ITEM #: 6.23	COMMITTEE OF ADJUSTMENT REPORT MINOR VARIANCE APPLICATION A136/22 42 Stilton Ave Kleinburg ON L4H 5B9
---------------------	--

**COMMITTEE OF ADJUSTMENT REPORT
MINOR VARIANCE APPLICATION
A136/22
42 Stilton Ave Kleinburg ON L4H 5B9**

ITEM NUMBER: 6.23	CITY WARD #: 1
APPLICANT:	Sarabjit Sekhon Kaur
AGENT:	Krishna Shah
PROPERTY:	42 Stilton Avenue, Kleinburg
ZONING DESIGNATION:	See below.
VAUGHAN OFFICIAL PLAN (2010) DESIGNATION:	Vaughan Official Plan 2010 ('VOP 2010'): "Low-Rise Residential"
RELATED DEVELOPMENT APPLICATIONS:	None
PURPOSE OF APPLICATION:	Relief from the Zoning By-law is being requested to permit a proposed secondary suite.

SITE PLAN

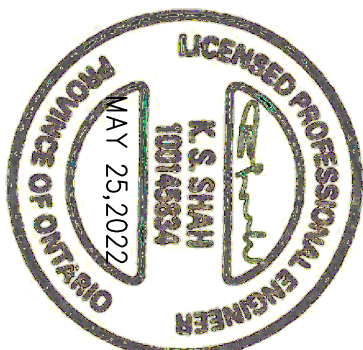
DEVELOPMENT ENGINEERING COMMENTS	
Link to Grading Permit Link to Pool Permit Link to Curb Curt Permit Link Culvert Installation	
Although the typical required setback for the side yard pavers is 0.6m from the property line, the permeable pavers to the secondary suite entrance proposed by the applicant will facilitate the drainage.	
The Development Engineering (DE) Department does not object to variance application A136/22 subject to the following condition(s):	
Development Engineering Recommended Conditions of Approval:	<p>Staff have confirmed that the property is located within an unassumed subdivision. The Owner/applicant shall provide satisfactory notification to the developer/builder and approval (Letter or email) of the minor variance and proposed work to the property in question and provide a copy of the notification and approval to the City's Development Engineering Department.</p> <p>The Owner shall provide a written Letter of Undertaking (template can be requested from DE) to the satisfaction of Development Engineering to install permeable pavers in order to facilitate drainage as per design drawing prepared by Excel Engineering Inc. provided on May 25, 2022.</p>

The Owner is requesting relief to permit the construction of a hard landscape walkway to provide access to a proposed secondary suite entrance in the northern side yard. The proposed walkway will run through the southern side yard and wrap around the rear of the dwelling.

The Development Planning Department has no objection to Variance 1 as the proposed hard landscape walkway will consist of permeable pavers, which the Development Engineering Department has reviewed and is satisfied that drainage along both side yards will be maintained. The hard landscape walkway facilitates the required 1.2 m clear path to the secondary suite entrance.

The Development Planning Department has no objection to Variances 2 and 3 as the encroachment caused by the one window well near and below grade along the south wall is minor in nature and will not impede safe access to the secondary suite.

#	DEPARTMENT / AGENCY	CONDITION(S) DESCRIPTION
1	Development Engineering farzana.khan@vaughan.ca	<p>Staff have confirmed that the property is located within an unassumed subdivision. The Owner/applicant shall provide satisfactory notification to the developer/builder and approval (Letter or email) of the minor variance and proposed work to the property in question and provide a copy of the notification and approval to the City's Development Engineering Department.</p> <p>The Owner shall provide a written Letter of Undertaking (template can be requested from DE) to the satisfaction of Development Engineering to install permeable pavers in order to facilitate drainage as per design drawing prepared by Excel Engineering Inc. provided on May 25, 2022.</p>
